## STAFF REPORT

SUBJECT: MDA, PP, RZ - H-2021-0086  
Apex East Subdivision

#### I. PROJECT DESCRIPTION

Request to rezone 32.21 acres of land from R-4 to the R-8 zoning district, development agreement modification to create a new DA to develop the proposed preliminary plat consisting of 97 residential building lots and 14 common lots.

B. Preliminary Plat (date: 10/11/2021)

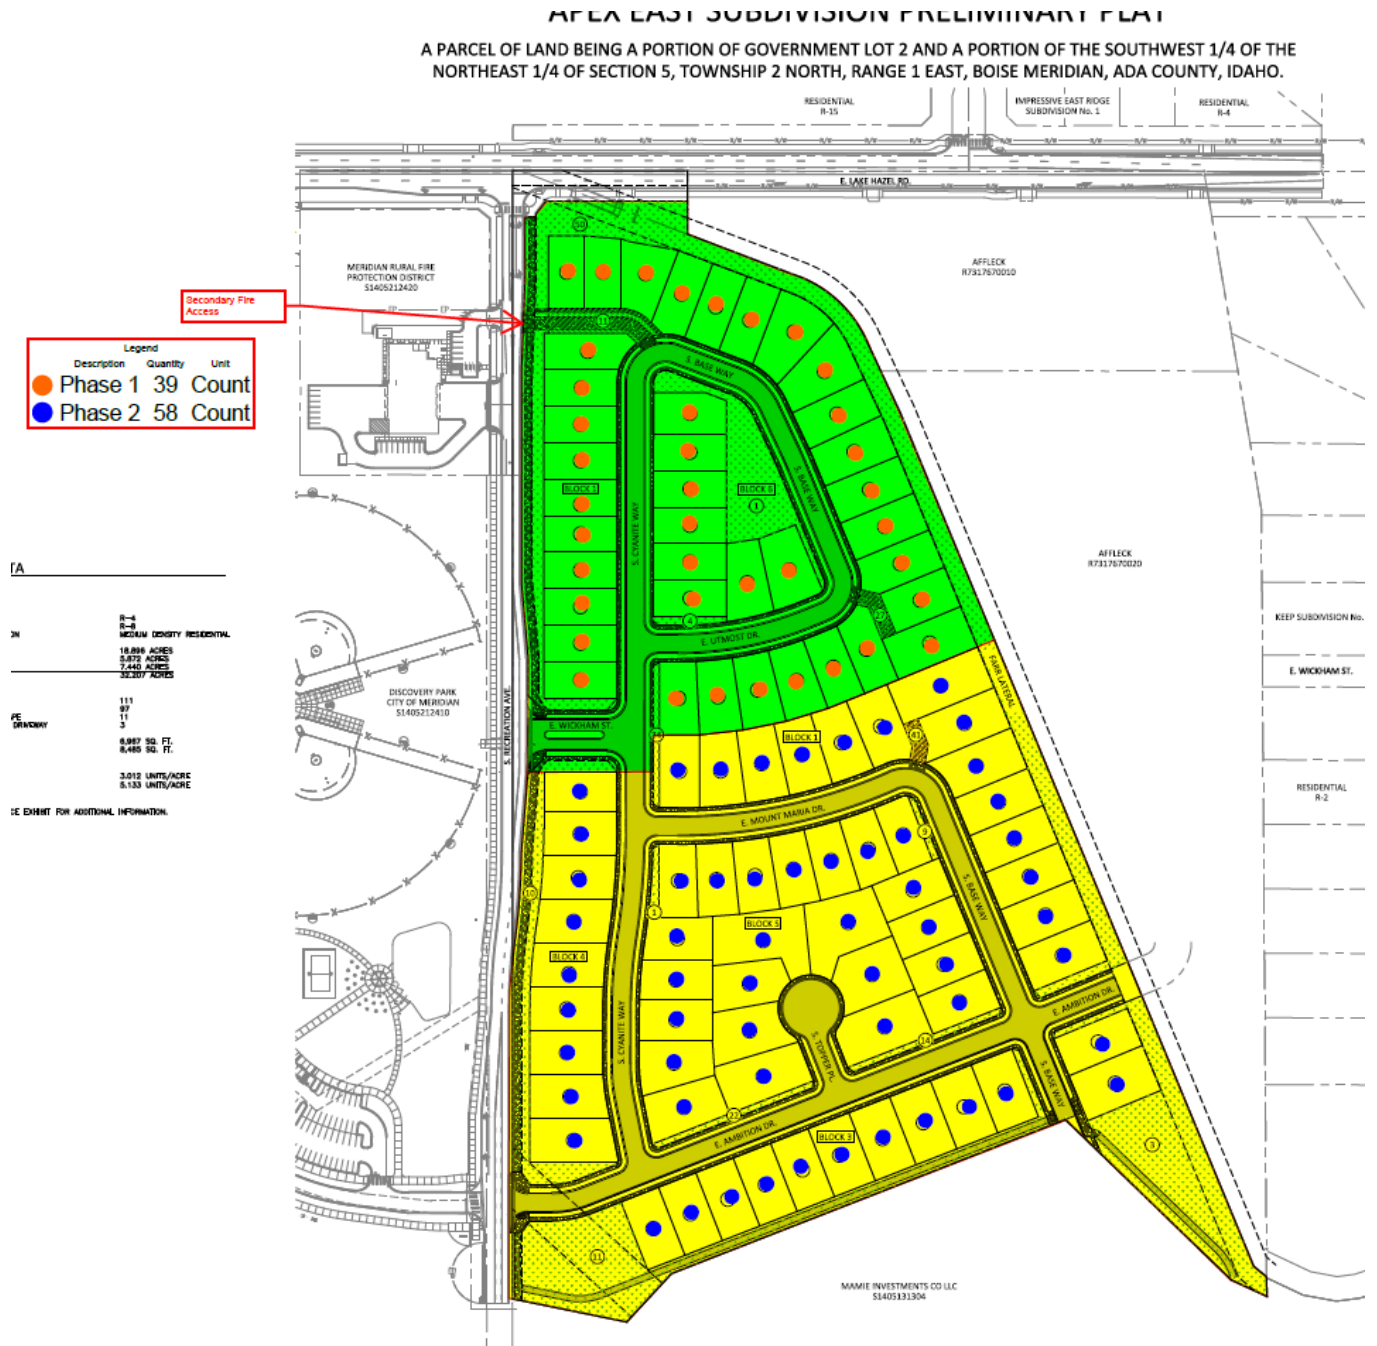
The elevations that were submitted suggest single family attached, although the plat as submitted does not reflect an even number of lots and does not indicate which lots would contain the attached product. Prior to Council, the applicant should revise the plat to depict the single family attached lots (zero setback side lot lines).

2. The Preliminary Plat included in Section VI, dated 10/11/21, is approved with the following revisions:
    - a. The plat should indicate which lots will contain single family attached (zero side lot lines).

- b. Add notes which indicate Lots 3 and 50 Block 1, Lots 10 & 11 Block 4, Lot 1 Block 6, are common lots which will be owned and maintained by the homeowner's association.

Color Landscape Plan (date: 10/11/2021)

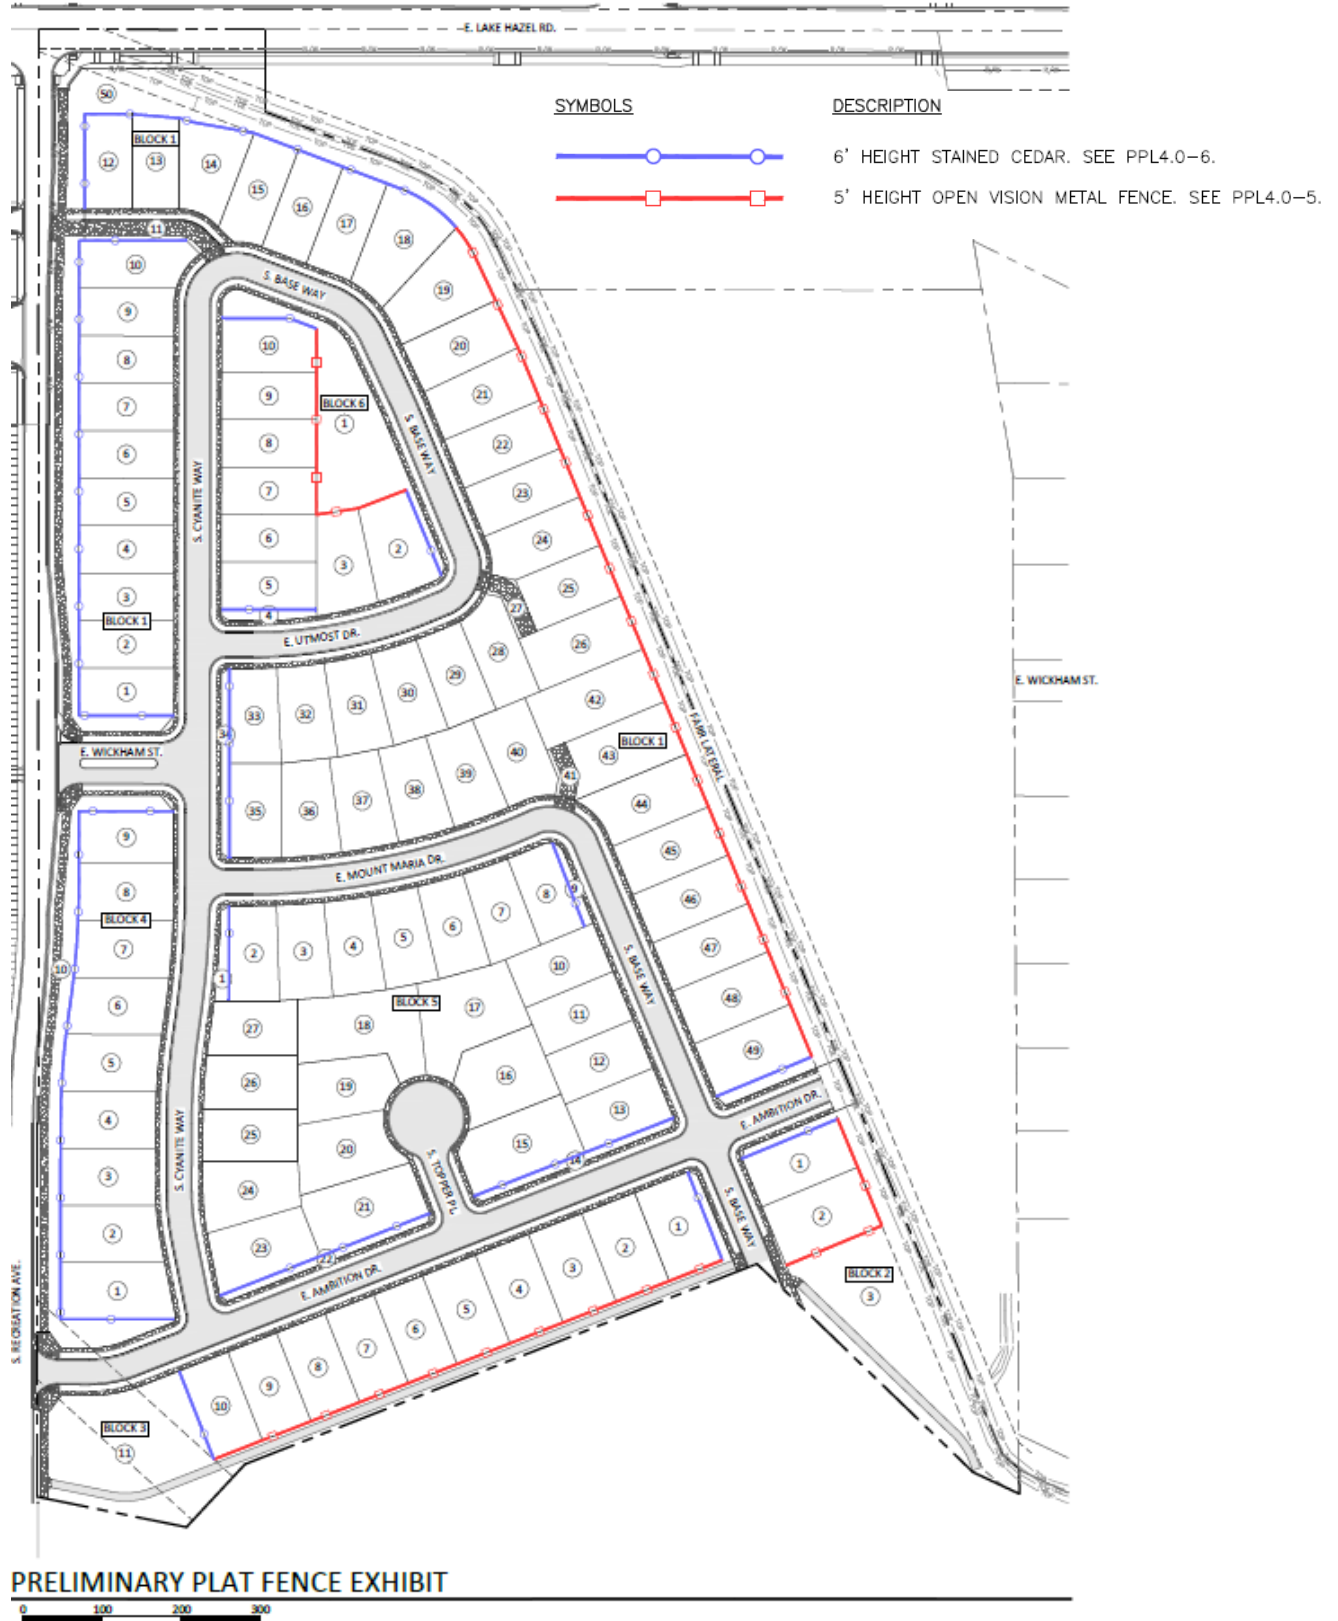
Staff does think the southern pathway (connecting to the Farr Lateral) should align with the eastern entrance into Discovery Park on the opposite side of S. Recreation Ave. (see the color landscape plan in Section VII). Staff has concerns the westernmost segment of the pathway will encourage people to cross S. Recreation Ave. out of a designated crosswalk or "cut across" the open space in the vicinity of the Williams Pipeline Easement. Staff recommends the plat and landscape plan be revised to provide a more direct and aligned connection between the southernmost pathway and the entrance into Discovery Park.

- e. Prior to Commission, plat and landscape plan shall be revised to provide a more direct and aligned connection between the southernmost pathway and the entrance into Discovery Park at the west.

E. Common Open Space Exhibit (date: 10/11/2021)

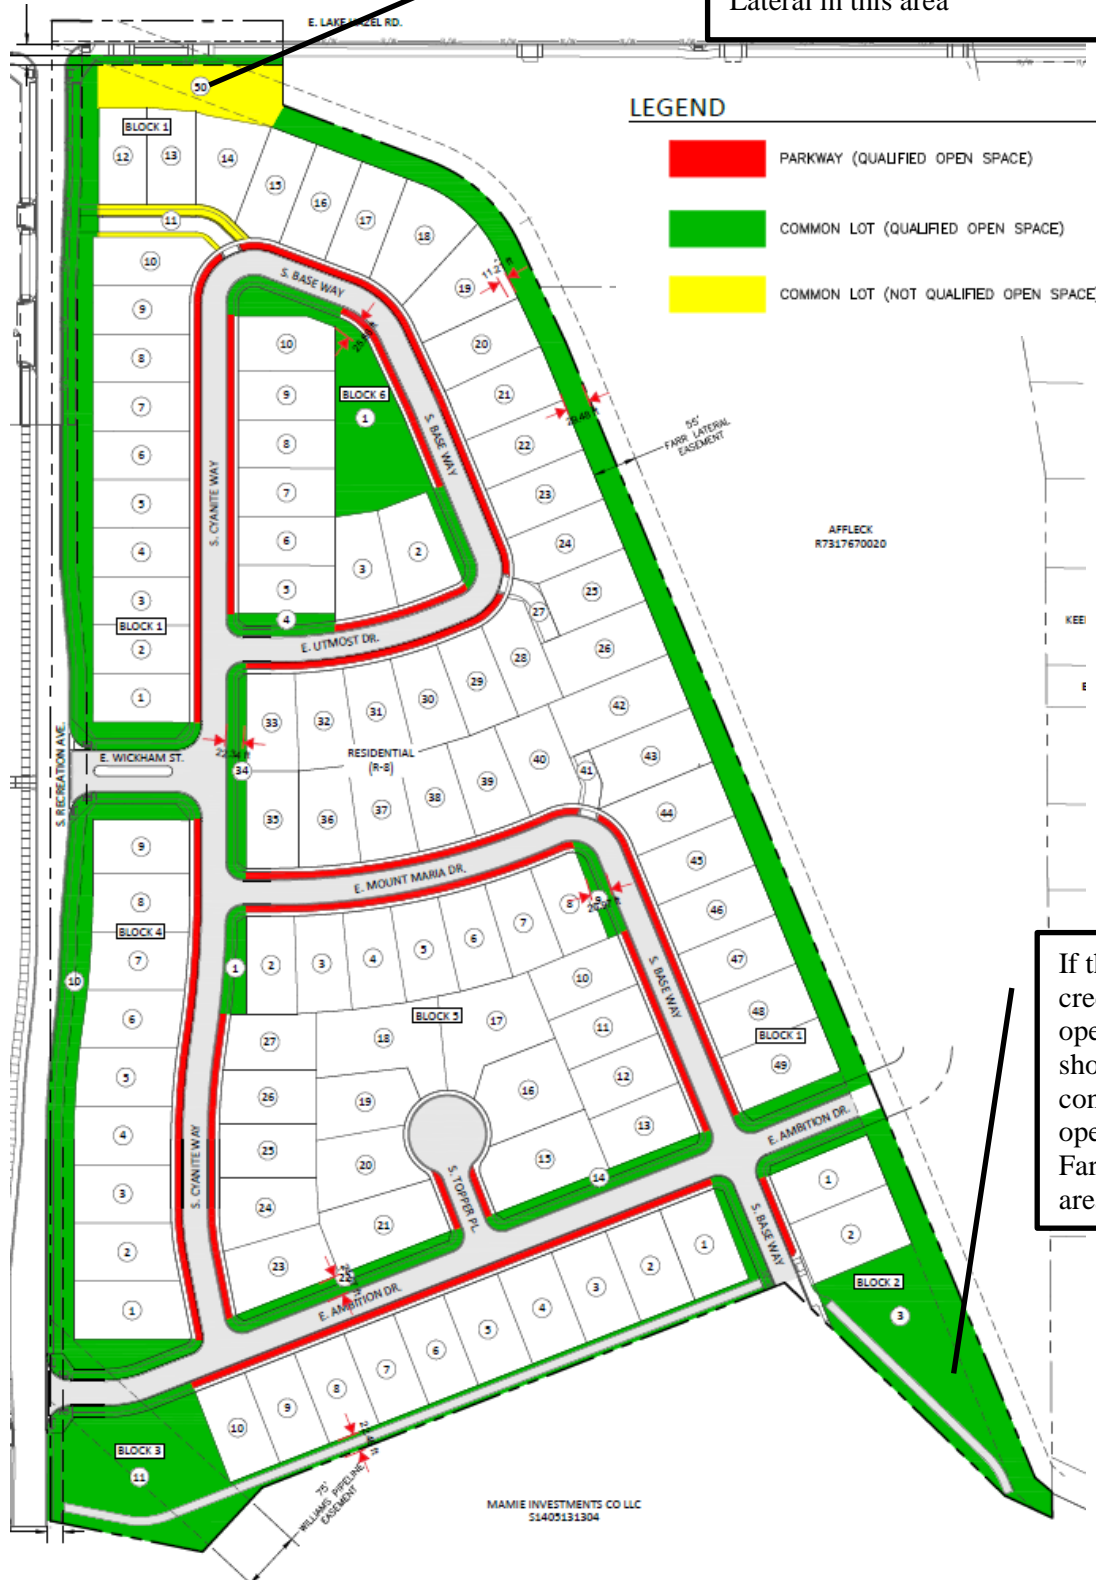
The open space exhibit includes the 55 ft. wide Farr Lateral easement along the eastern property line. UDC 11-3G-3B states protective buffers a minimum of ten feet (10') in width dedicated for active access along laterals or ditches may count toward meeting the open space minimum requirements. However, as presently shown, staff is unsure this area provides the "active access" required to be counted as qualified open space. Because this lateral is behind existing homes, staff also has concerns regarding visibility and whether this area would comply with Crime Prevention Through Environmental Design (CPTED) standards. As a condition of approval, staff is recommending that prior to Planning Commission, the plat and landscape plan be revised to provide access to some or all of the open area shown along the Farr Lateral. Only areas accessible and useable to the residents as open space should be included on the open space exhibit. Also, if this area is to be credited as qualified open space, it should be landscaped as required by UDC 11-3B unless otherwise prohibited by the irrigation district.

If this is going to be credited as qualified open space, there should be a connection to useable open space along the Farr Lateral in this area

If this is going to be credited as qualified open space, there should be a connection to useable open space along the Farr Lateral in this area

- c. All utility easements reflected on the utility plan shall be included on the plat.
    - d. Prior to Commission, the plat and landscape plan shall be revised to provide access to some or all of the open area shown along the Farr Lateral. Only areas accessible and useable as open space to the residents for active or passive recreation should be included on the open space exhibit.

- a. If the Farr Lateral Easement is to be credited as qualified open space, it should be landscaped as required per UDC 11-3B, or as allowed by the irrigation district.
